Request for Change Order

La Vernia ISD 2023 Bond Projects (231091)

No. **RCO0101R1**

Description	PR#92 - JHS Tennis Court Lighting Revisions	Date	2026-07-08
Status:	Pending Review	Days Impact:

Grid Summary	
Name:	Tennis 3-4
Size:	2 Court - 12' Spacing
Spacing:	20.0' x 20.0'
Height:	3.0' above grade

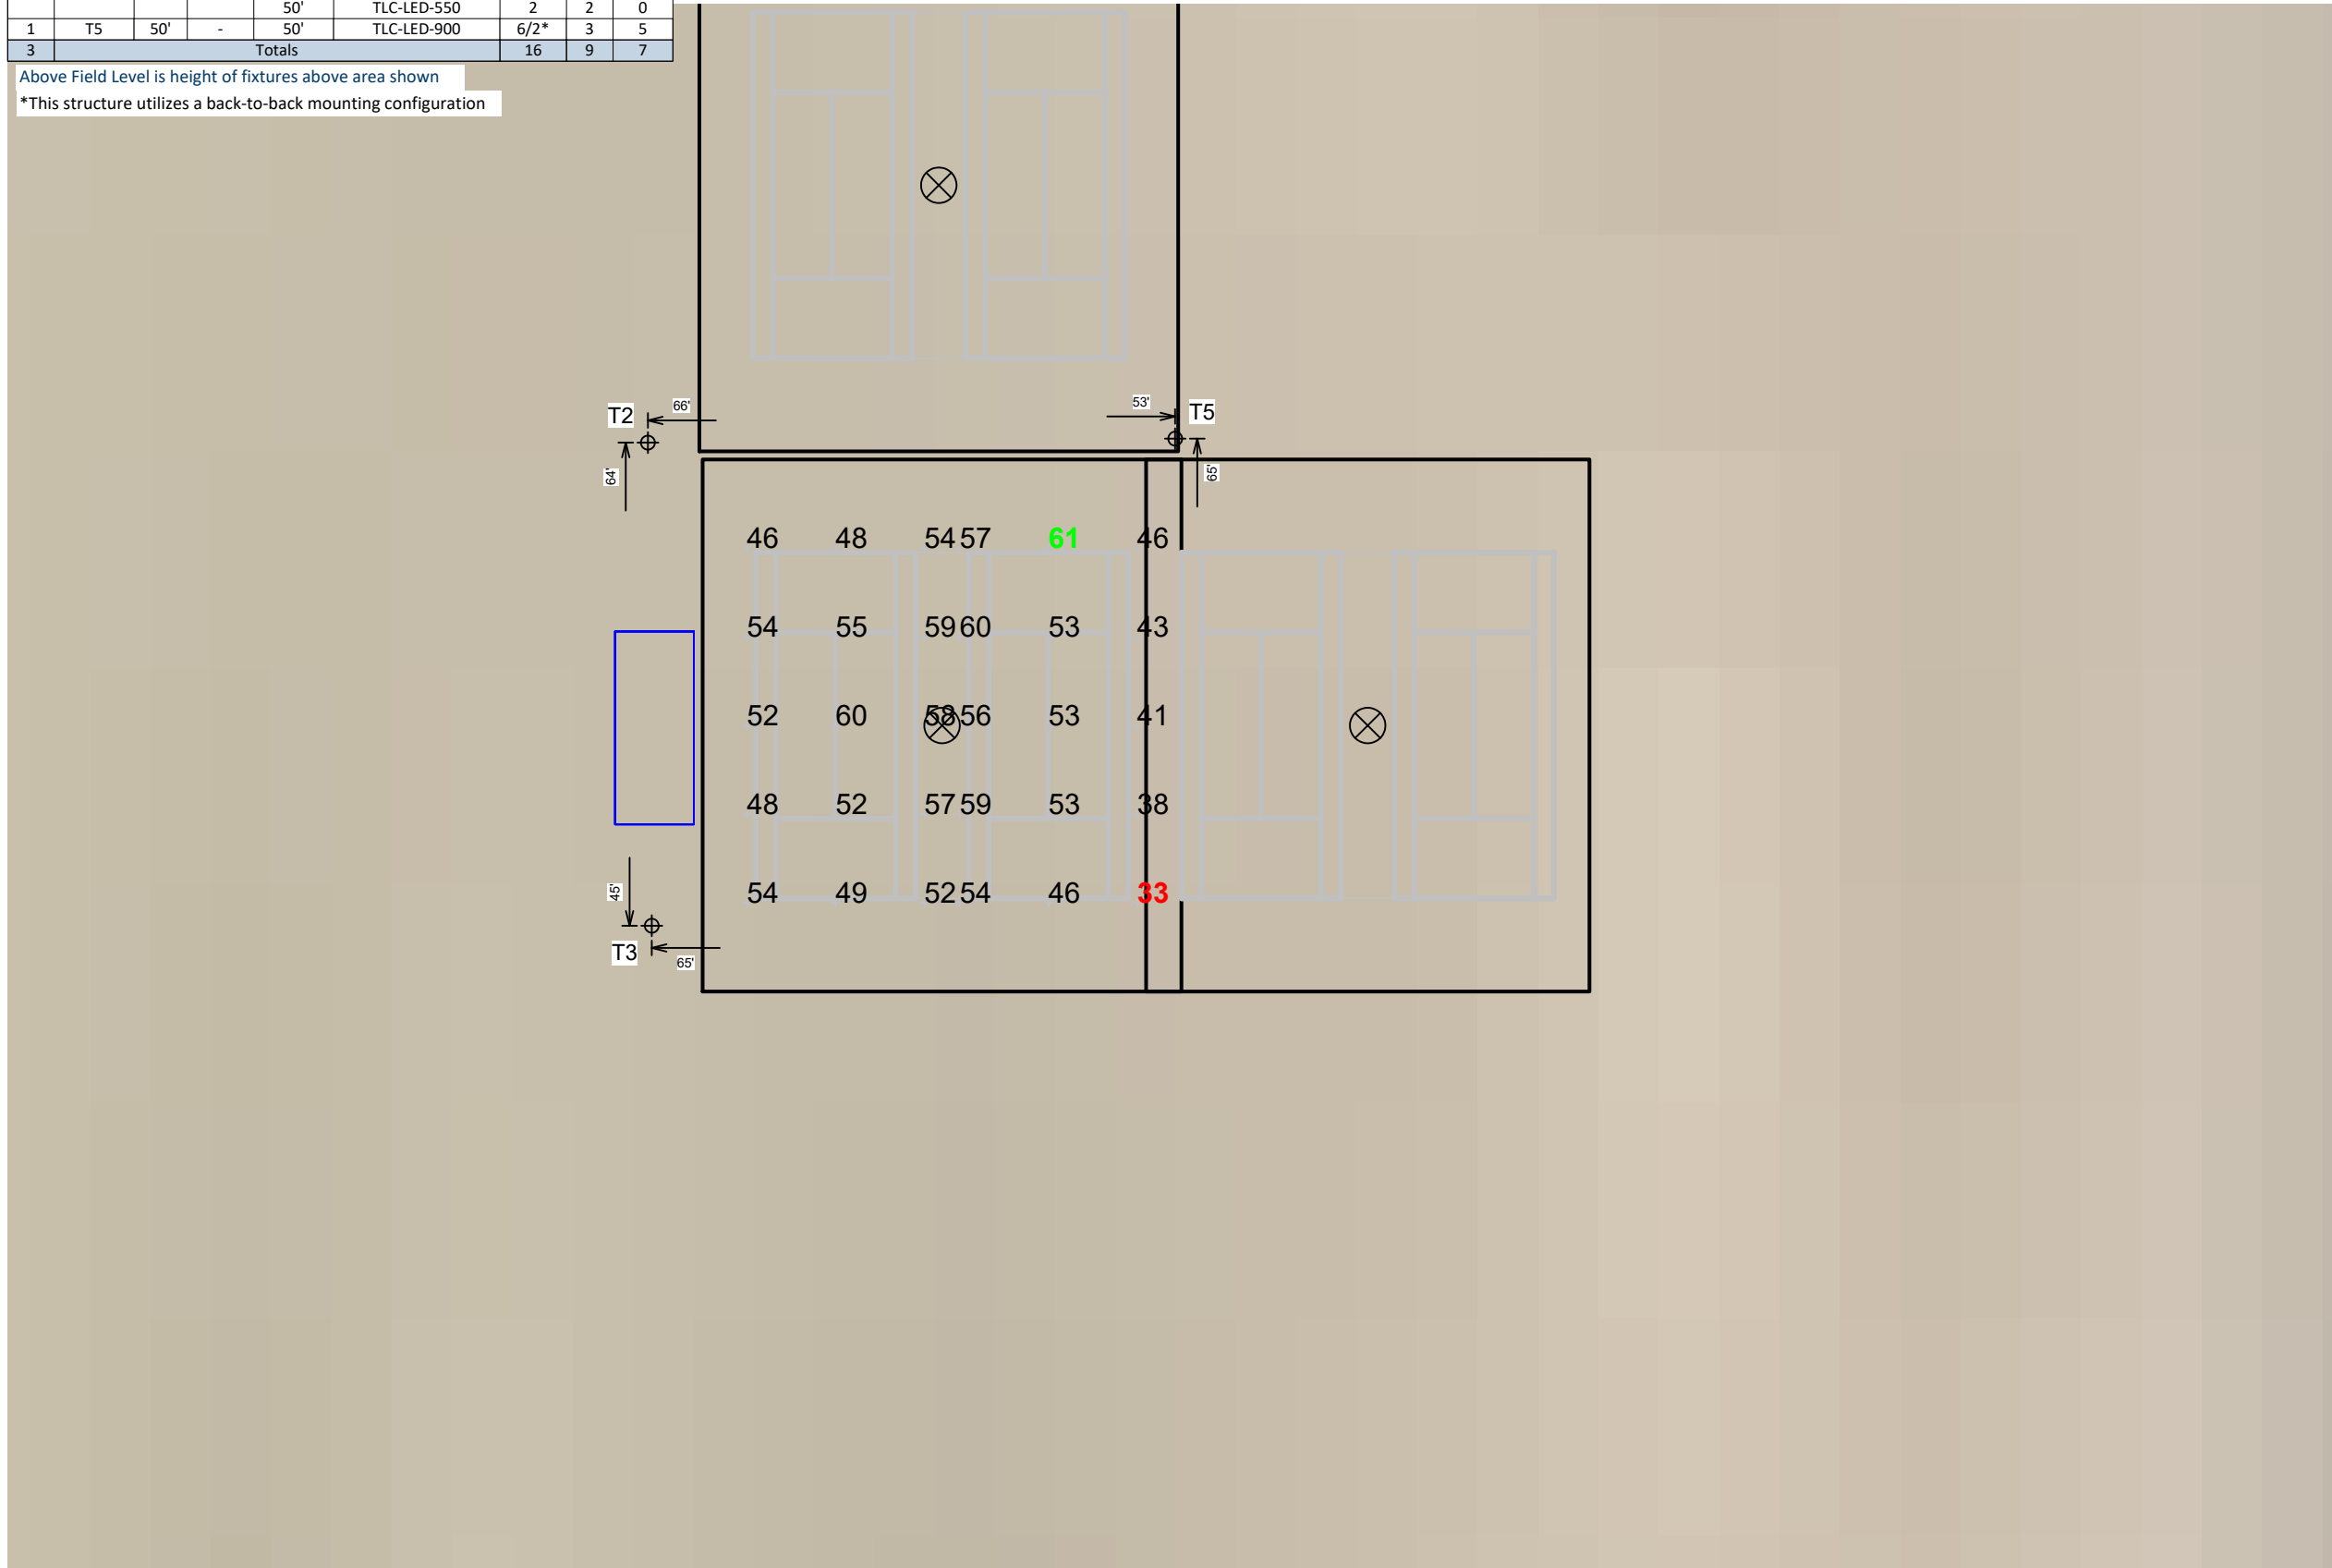
- Based on the attached foot-candle analysis, can you confirm that the revised cost you provided to IES includes provisions for light fixtures on the backside of the back court?

Equipment Layout

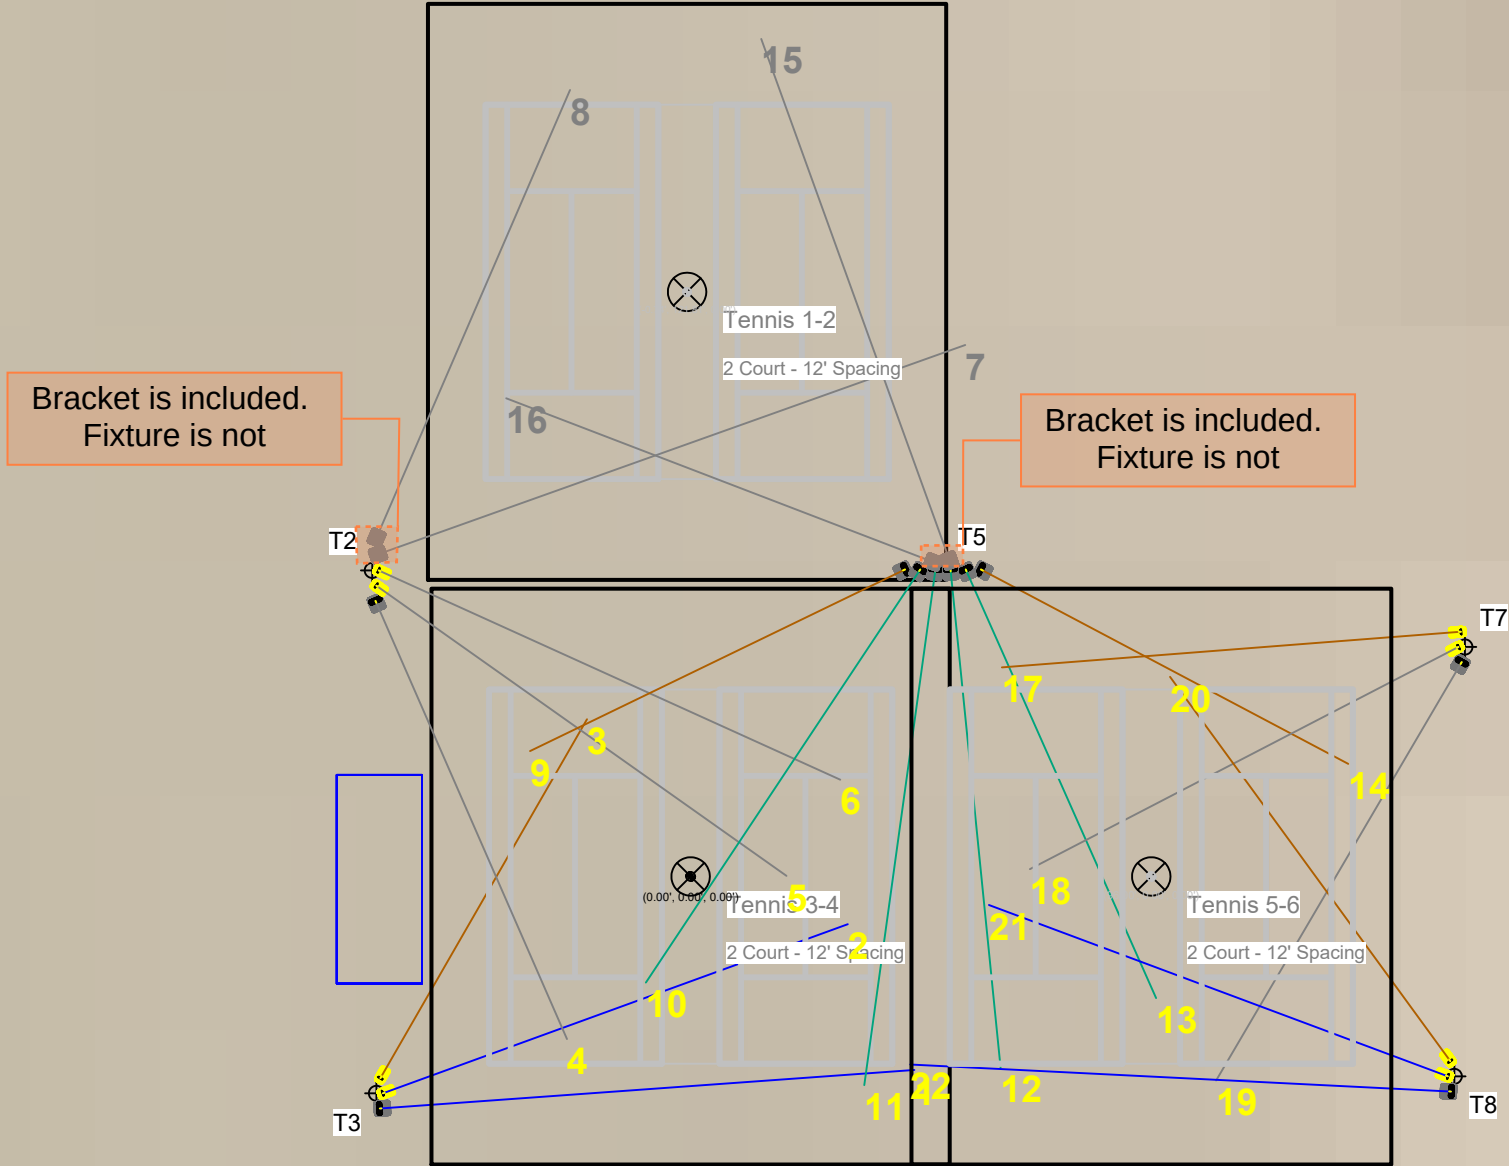
I have attached our photometrics that we did for the remaining 5 poles. If look at the last page you will notice that poles T5 and T2 have gray lines pointed at the north two courts. That means that if the school would like to add fixtures to those poles to light the two north courts down the road they would have that capability. When the school purchased this system back in the day those poles were already up sized and built to hold future fixtures for those courts so the LED configuration would allow for the same.

Alternate pricing to provide lighting for the back tennis court will be submitted under separate cover. This RCO includes the brackets needed to add fixtures to poles T2 and T5 for the back court. The additional light fixtures for the back court are not included in this pricing and will be addressed separately.
